### ADDENDUM 1

## Austin Elementary School Heating & Air Condition (HVAC) Improvements Funded through the Elementary & Secondary Emergency Relief (ESSER) Funds May 31, 2022

## Addendum

**PROJECT** 218007.004 | Edinburg CISD - Stephen F. Austin ES - HVAC Improvements

DATE:	05/05/2022
DRAWN BY:	DBR
CHECKED BY:	DBR
PROJECT NUMBER:	218007.004
SHEET TITLE:	LEVEL 1 ELECTRICAL POWER PLAN - MAIN BUILDING - DEMOLITION
SHEET NUMBER:	EPD2.12

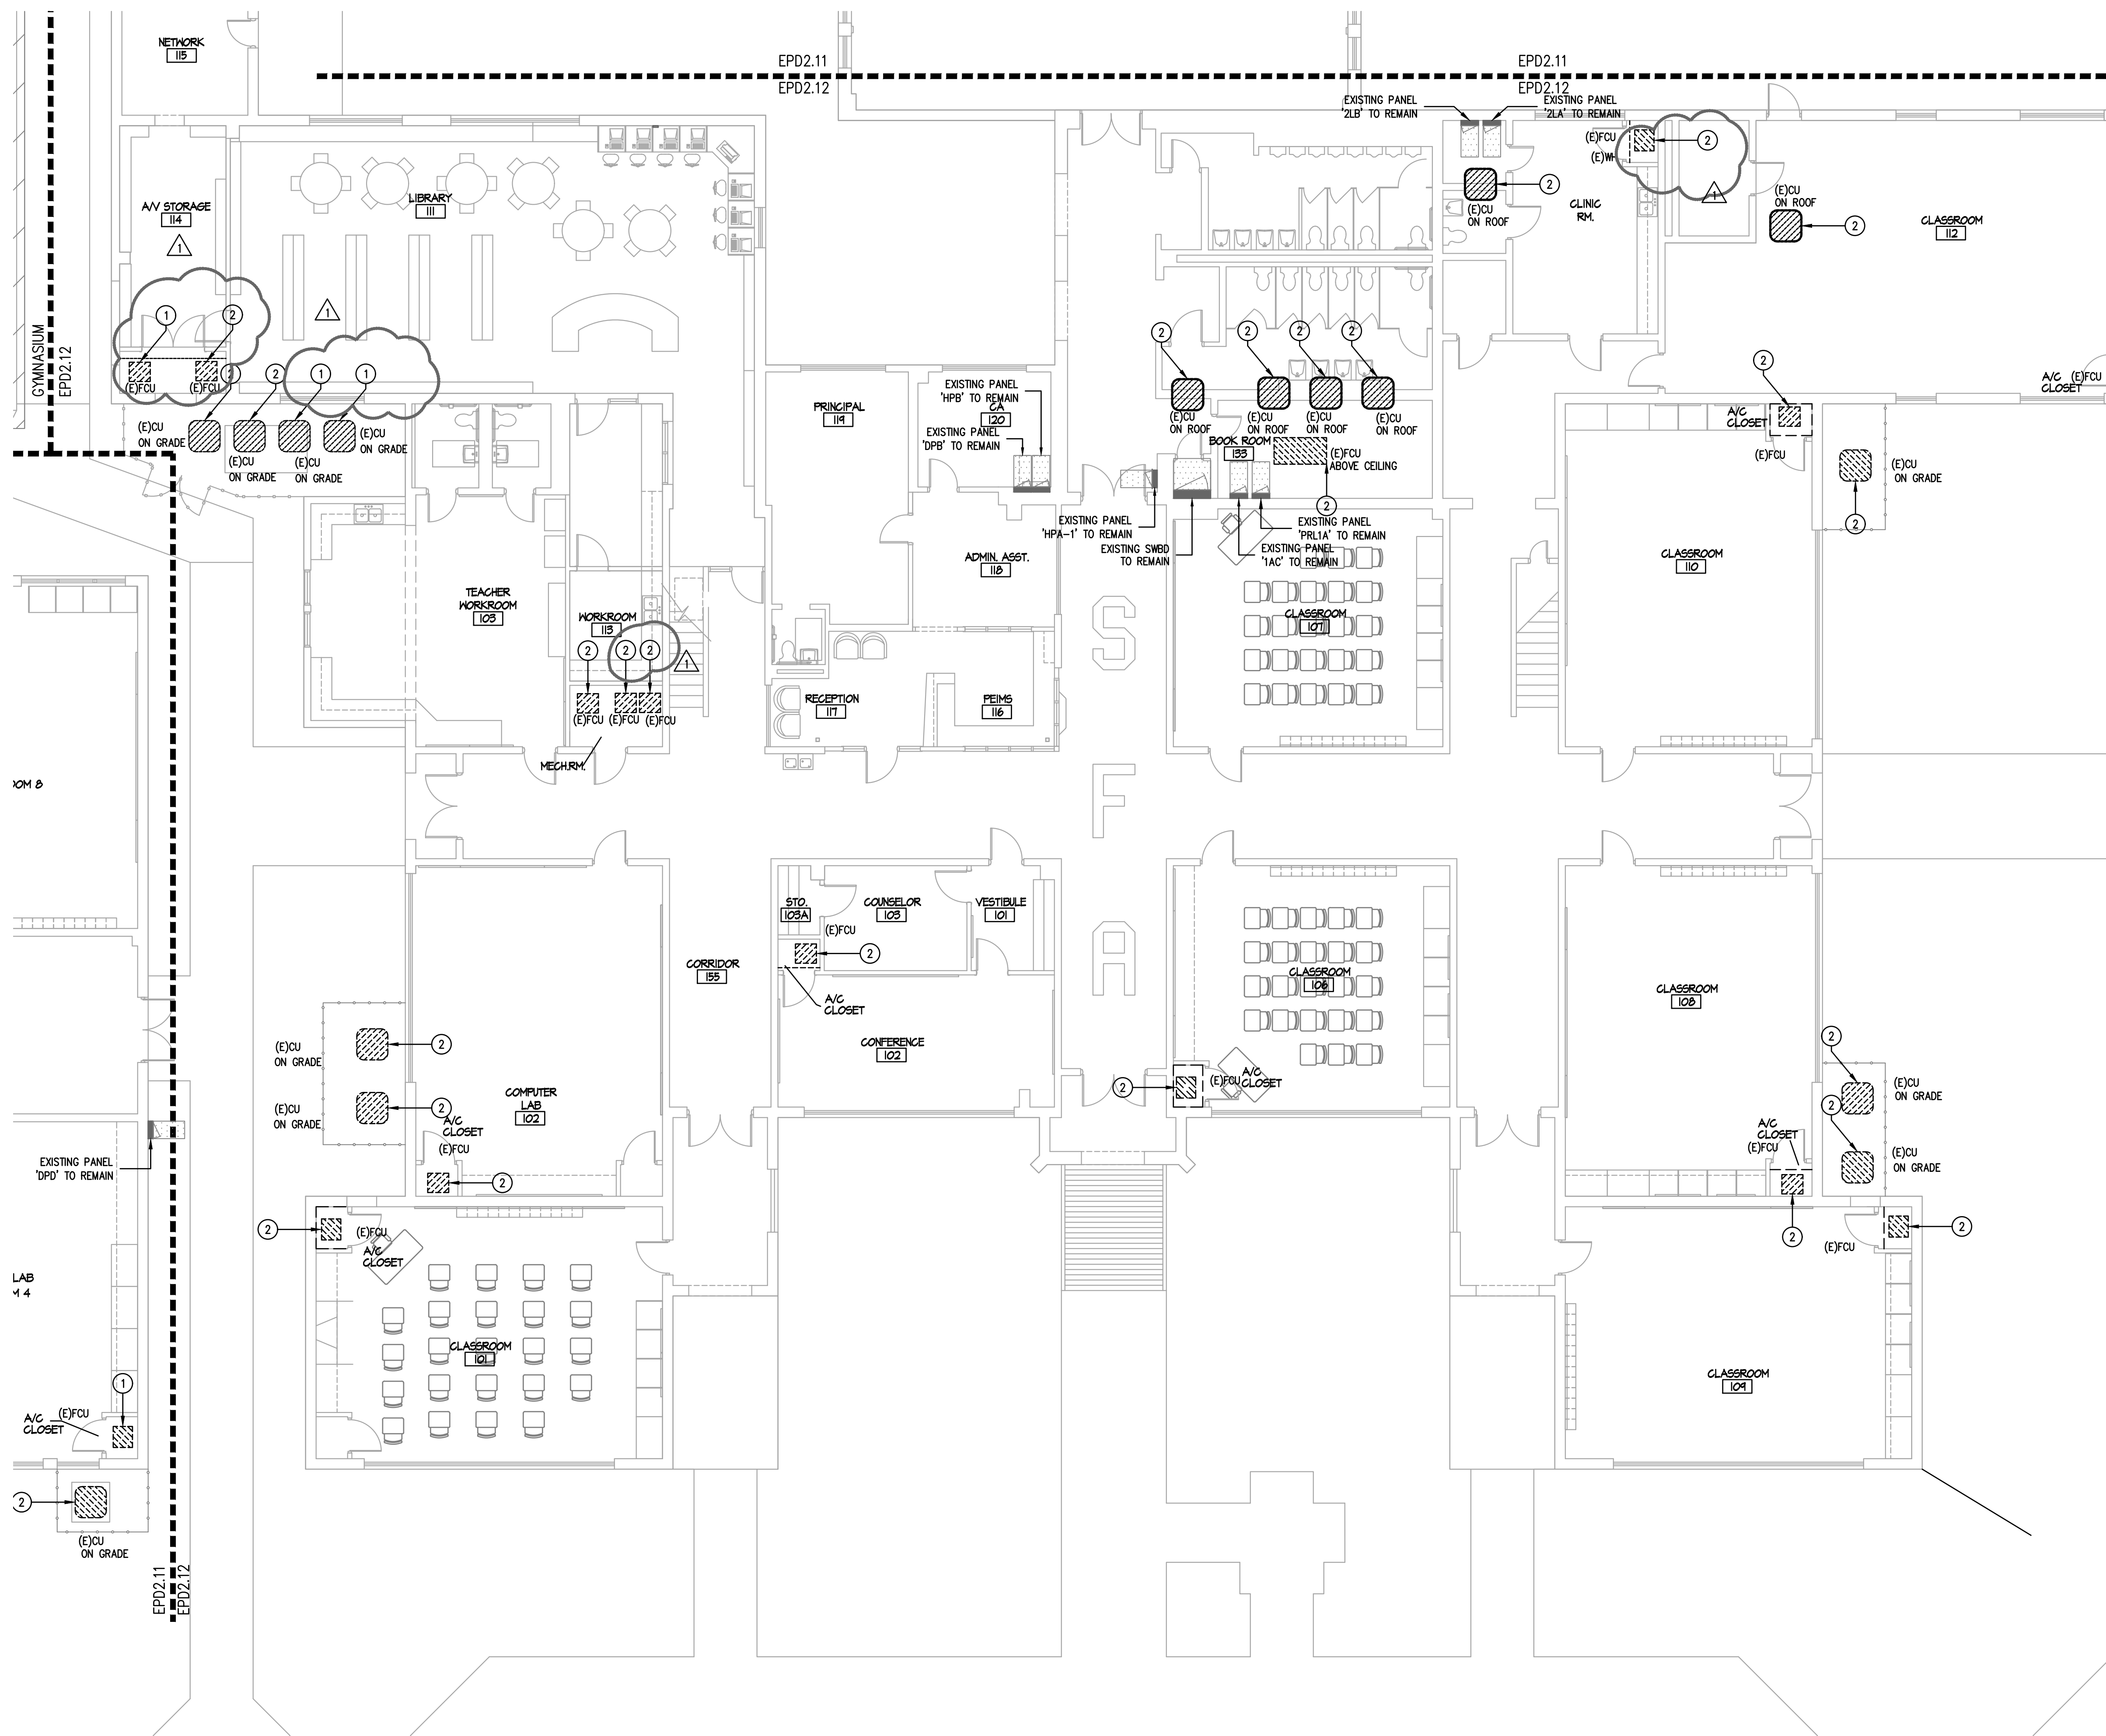
**Item 15 EPD2.12 – LEVEL 1 ELECTRICAL POWER PLAN – MAIN BUILDING - DEMOLITION**

- A. Revised keyed notes.
- B. Revised noted equipment.

**1** LEVEL 2 ELECTRICAL POWER PLAN - MAIN BUILDING - DEMOLITION  
 EPD2.21 1/8" = 1'-0"

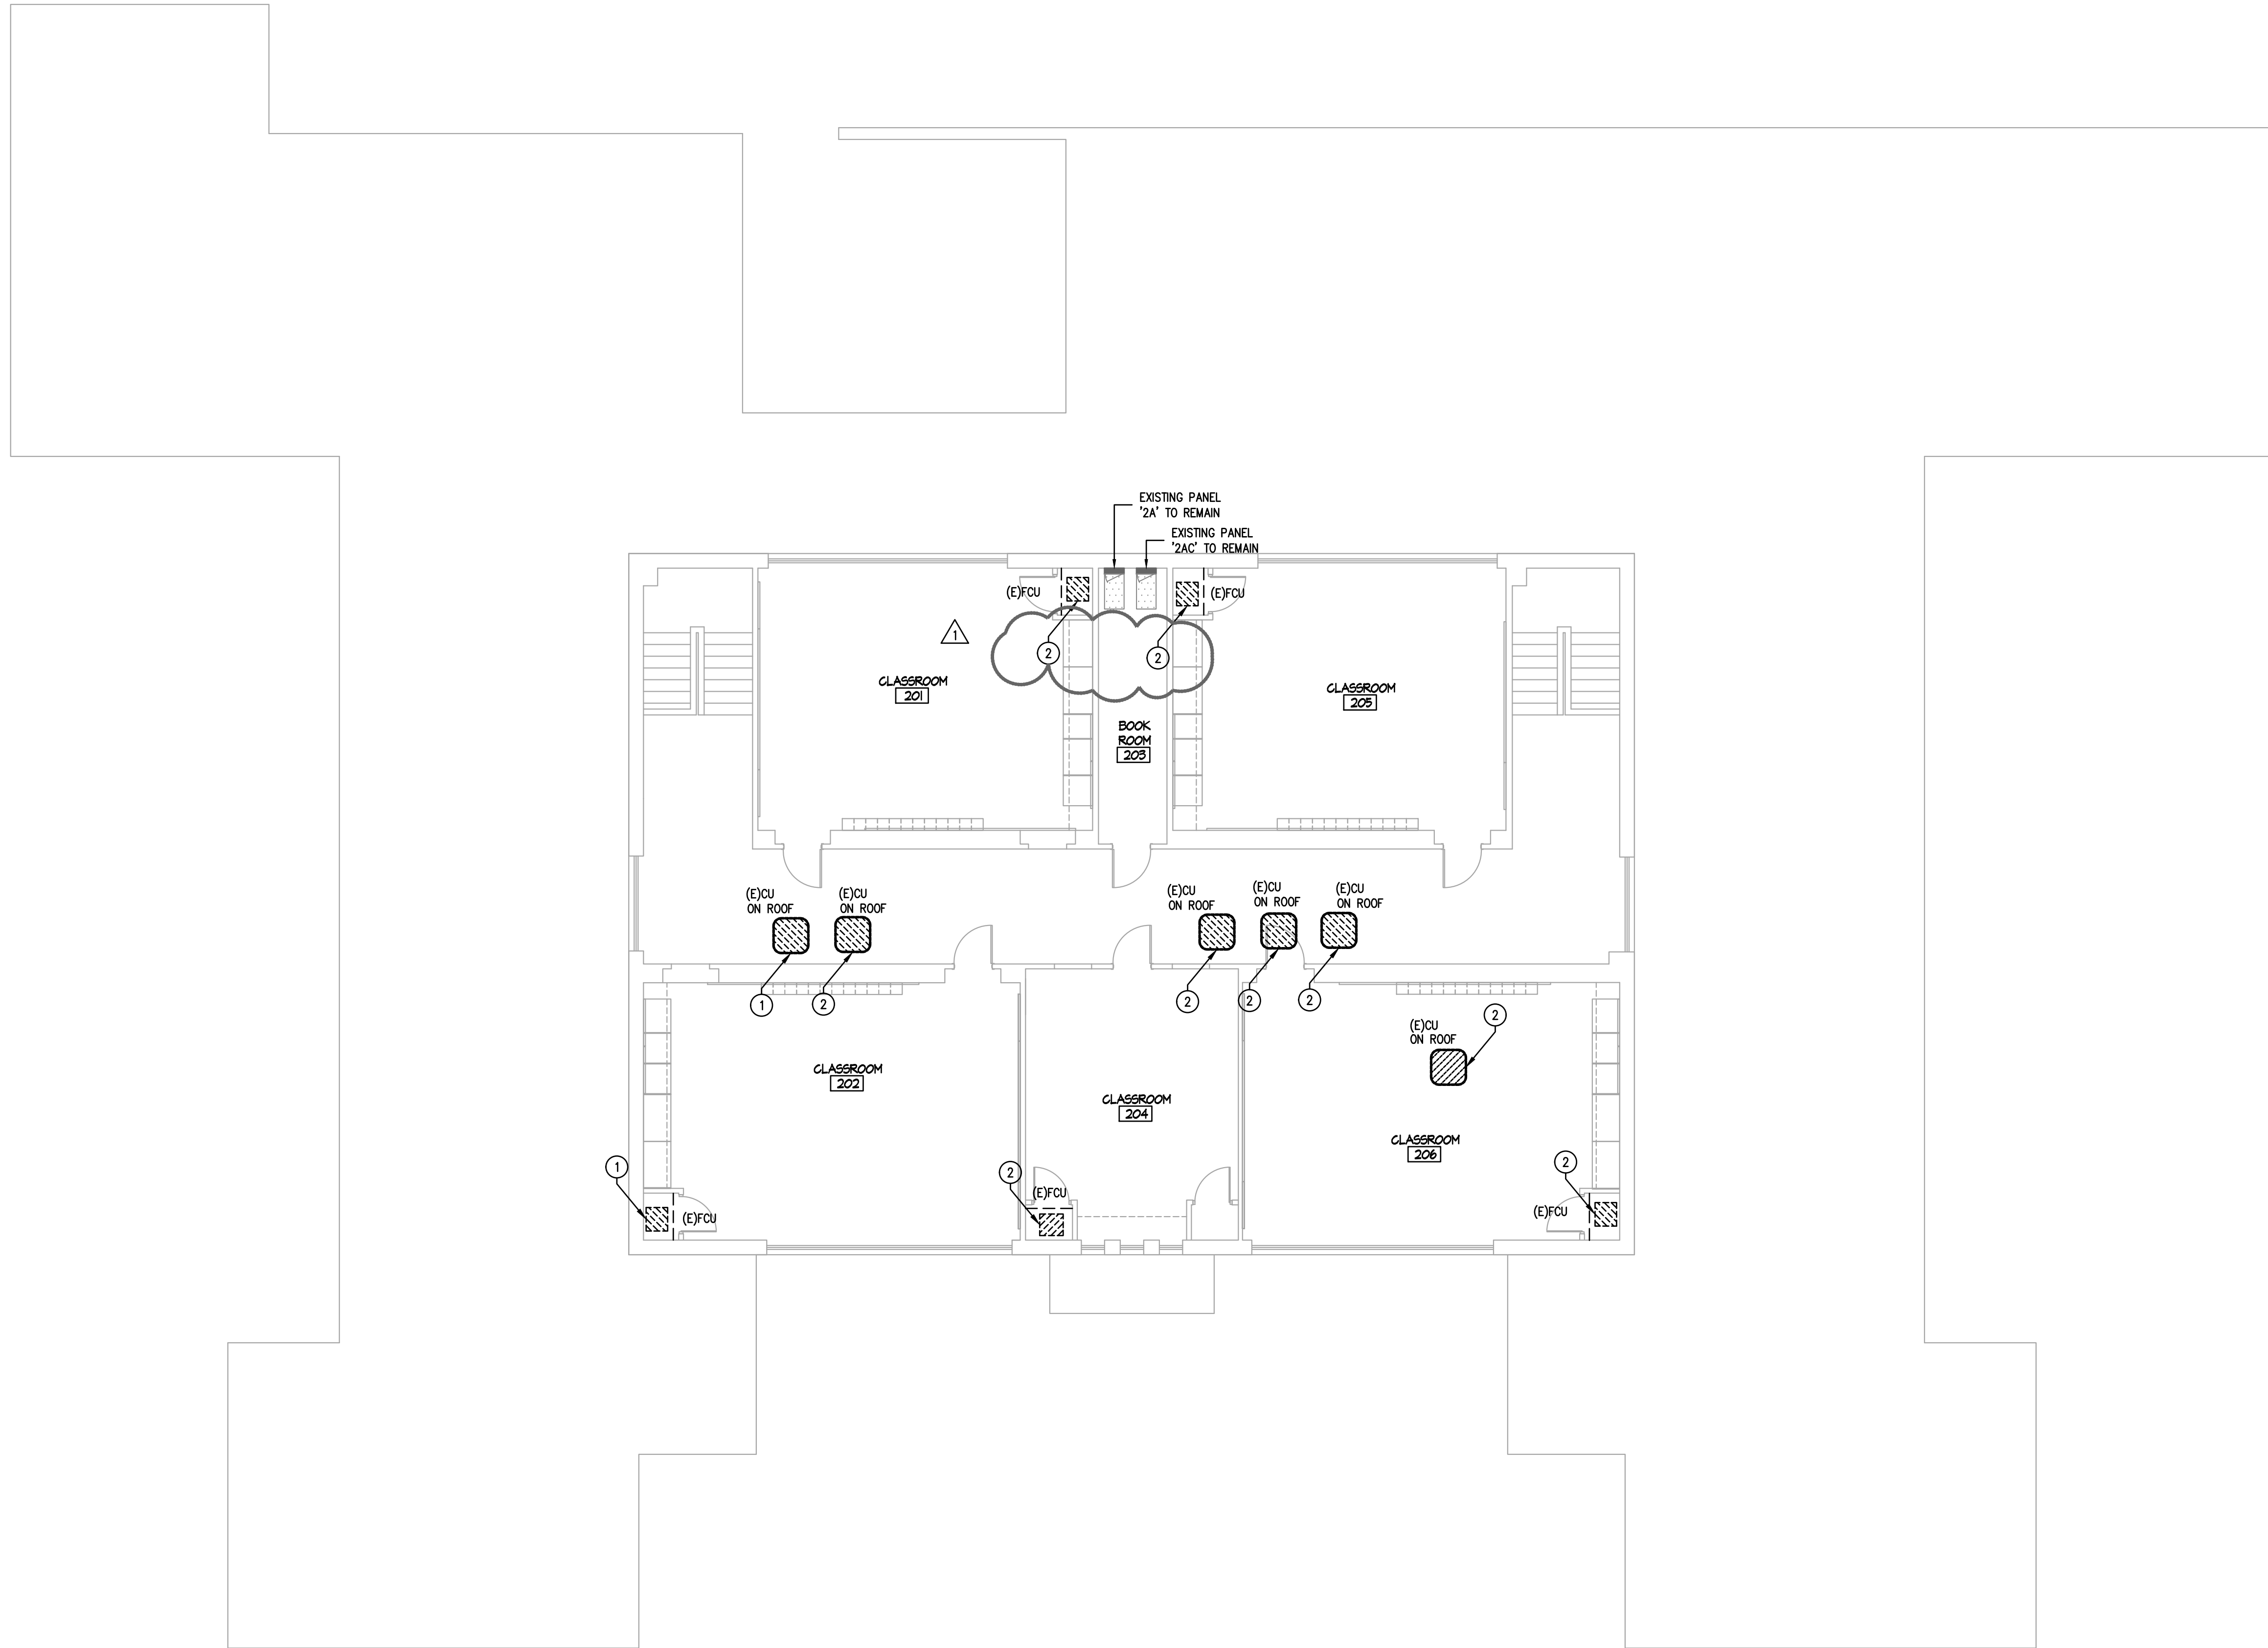
**Item 16 EPD2.21 – LEVEL 2 ELECTRICAL POWER PLAN – MAIN BUILDING - DEMOLITION**

- A. Revised keyed notes.
- B. Revised noted equipment.
